SUBJECT: RELOAD SUBMITTAL TO FACILITATE REVIEW OF THE CYCLE 12 AND SUBSEQUENT  
RELOADS PER 10 CFR 50.59 (TAC NO. 69235)

Re: Dresden Nuclear Power Station, Unit No. 2

The Commission has issued the enclosed Amendment No. 104 to Provisional  
Operating License No. DPR-19 for Dresden Unit 2. This amendment is in response  
to your application dated August 25, 1988.

Amendment No. 104  
License No. DRP-19

Figure 3.5-1  
(Sheet 1 of 3)

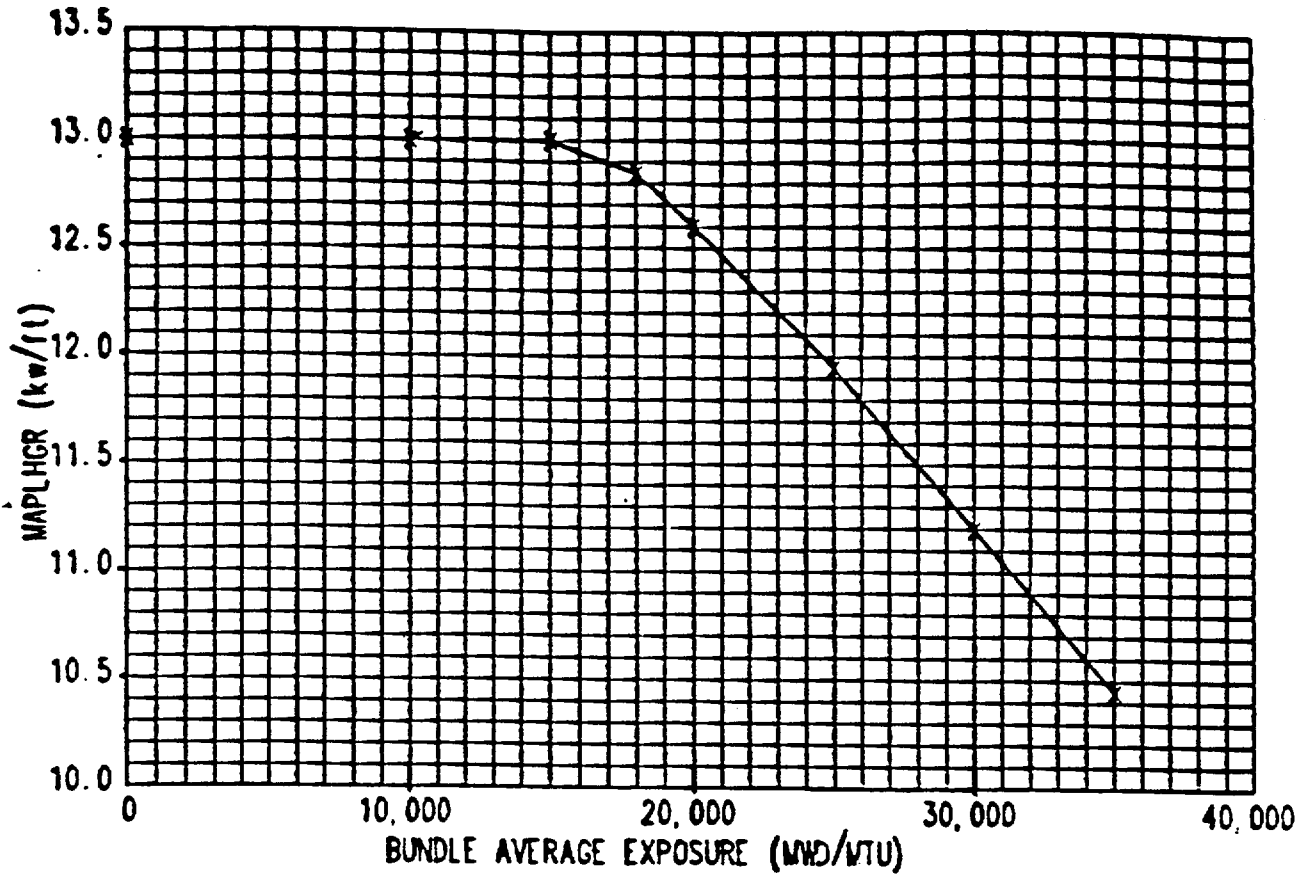
- (7) Specification 3.5.I: Figure 3.5-1 (Sheets 3, 4 and 5) are deleted and Sheet 3 (previously Sheet 6) is updated. These administrative changes are acceptable.

Bundle Average Exposure (MWD/MTU)	MAPLHGR Limit (kw/ft)
0	13.0
10,000	13.0
15,000	13.0
18,000	12.85
20,000	12.60
25,000	11.95
30,000	11.20
35,000	10.45

Figure 3.5-1A

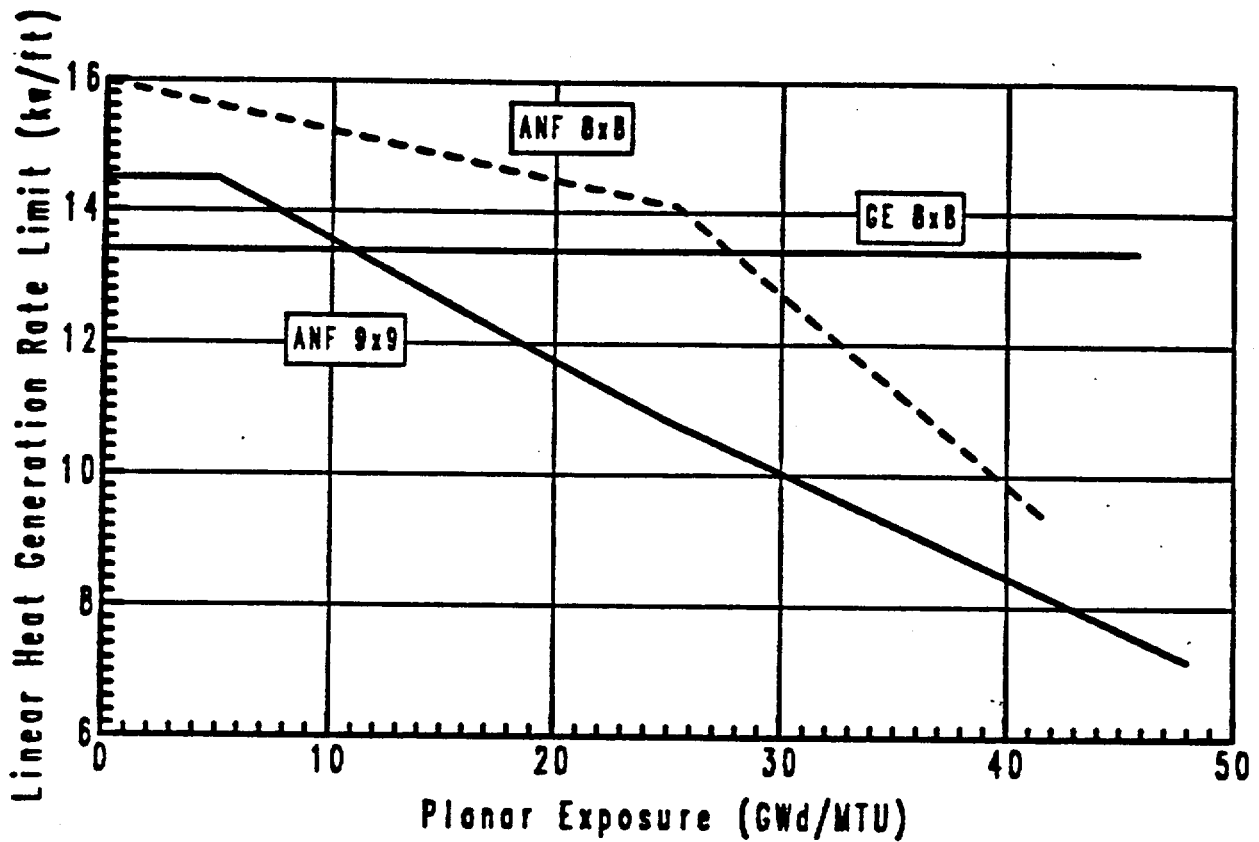
- (8) Specification 3.5.J, 4.5.J: The Section 3.5.J title is changed to "LOCAL STEADY STATE LHGR," references to FDLRX are added, and "STEADY STATE" is added to title of Figure 3.5-IA. These administrative changes are acceptable.

Figure 3.5-1A depicts the steady state LHGR values for ANF 8x8 and 9x9 fuel as a function of nodal exposure and for GE 8x8 fuel as a constant design value of 13.4 Kw/ft.

Figure 3.5-1B

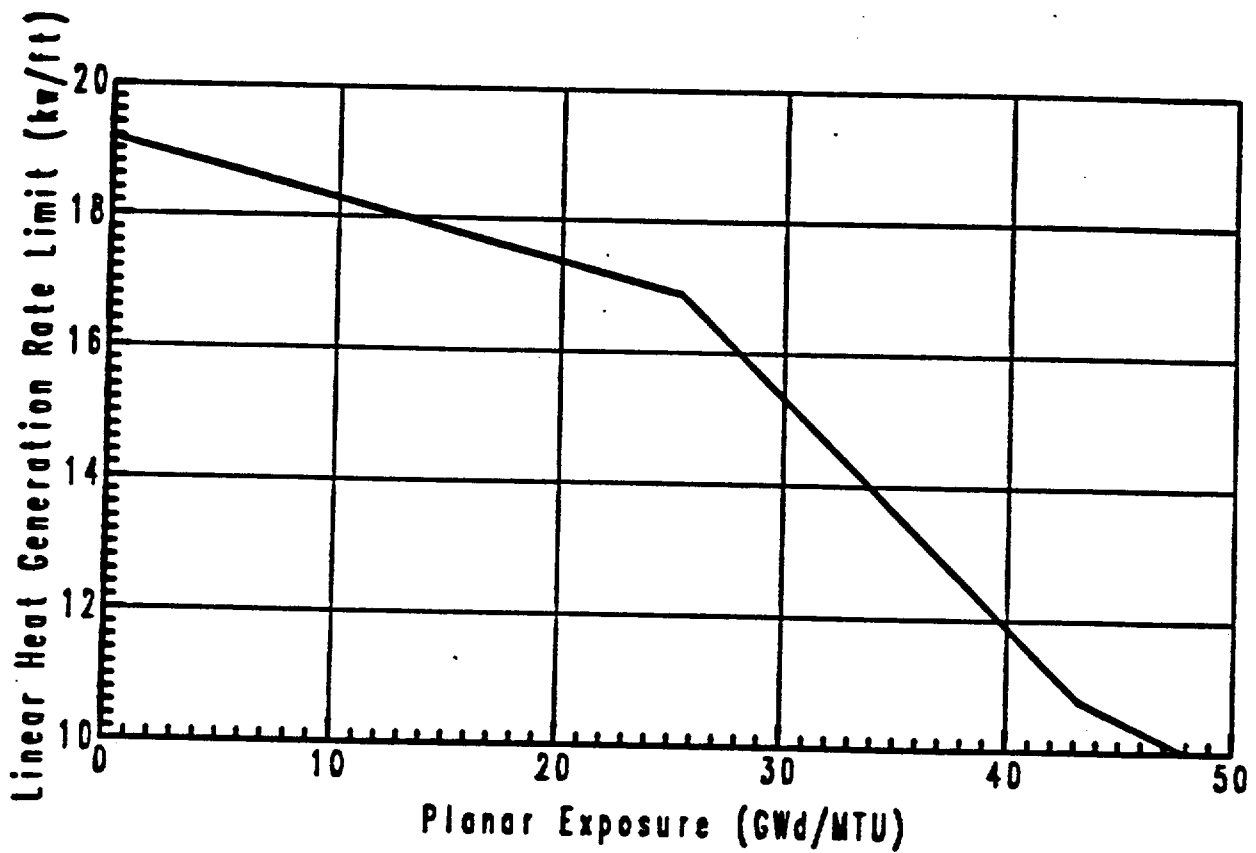
- (9) Specification 3.K.5: A new section on local transient LHGR and FDLRC is added as well as Figure 3.5-IB showing the transient LHGR limit curve. These administrative changes are acceptable.

Figure 3.5-1B depicts the TLHGR values for ANF 8x8 and 9x9 fuel as a function of nodal exposure.

Figure 3.5-2 (Sheet 1 of 2)

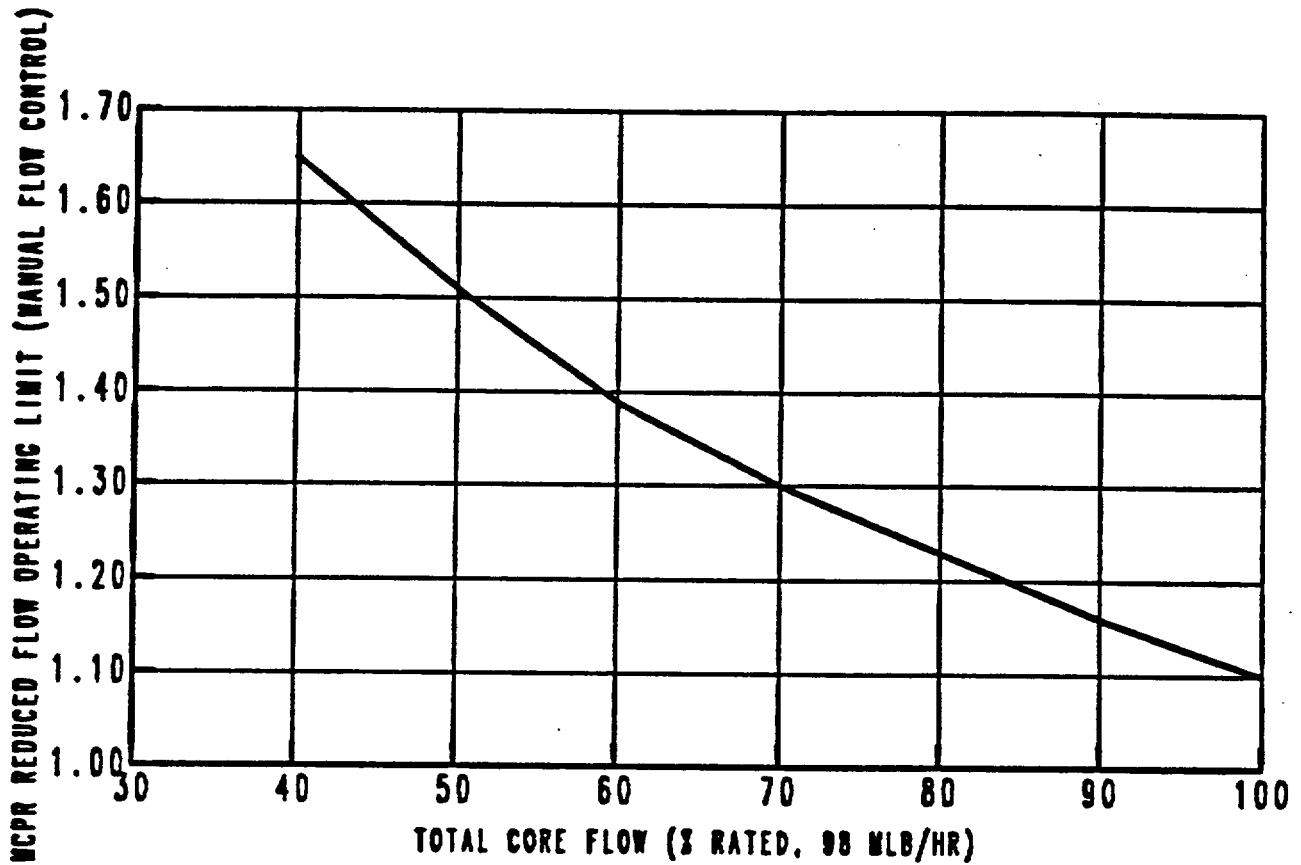
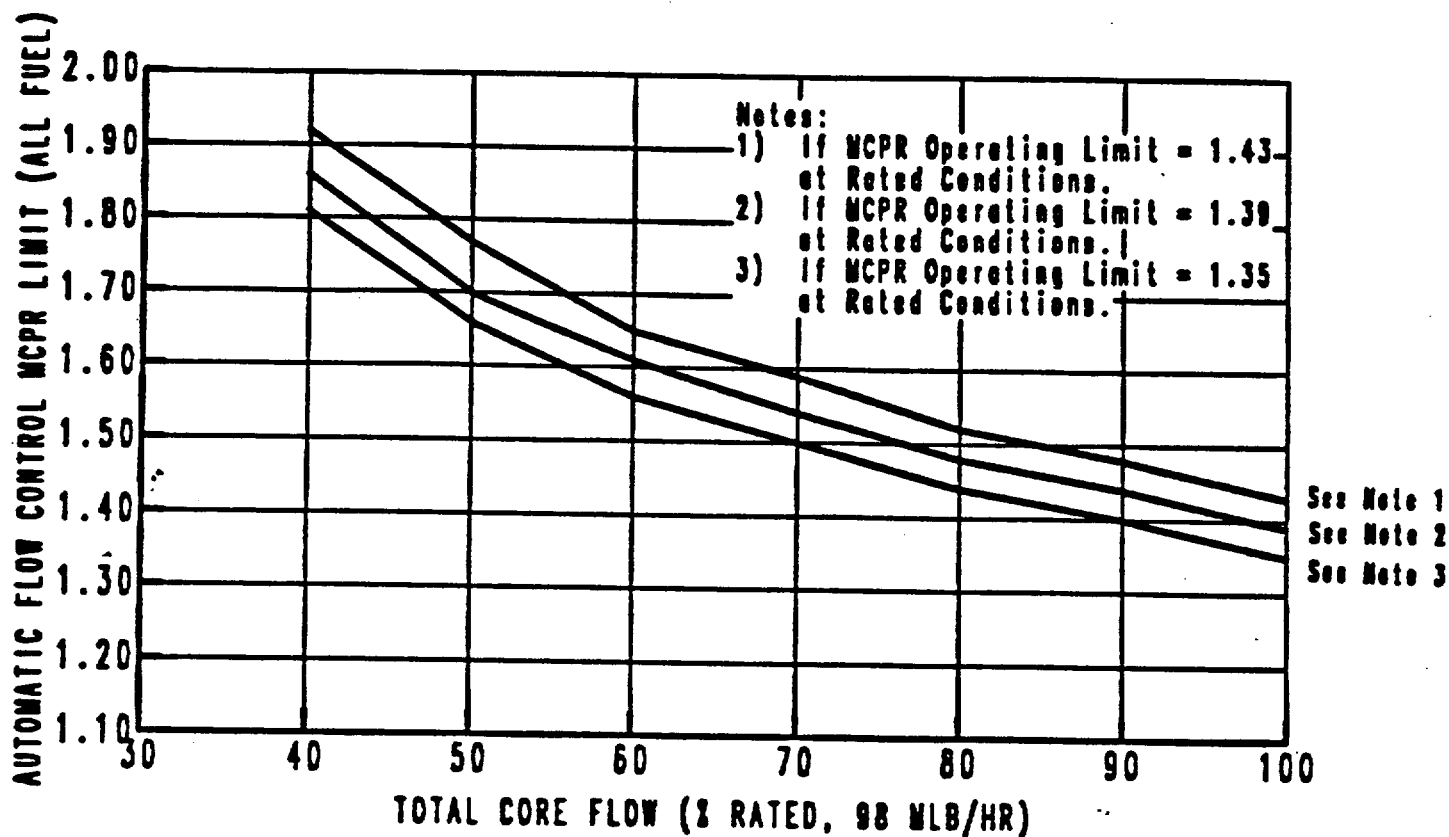
- (4) Specification 3.5.L.1 and Figure 3.5-2: The figure (Sheets 1, 2, and 3) is revised to incorporate changes in reduced flow MCPR values. This has been evaluated in Section 2.5 and found to be acceptable.

Total Core Flow (% Rated)	M CPR Operating Limits
100	1.10
90	1.16
80	1.23
70	1.30
60	1.39
50	1.51
40	1.65
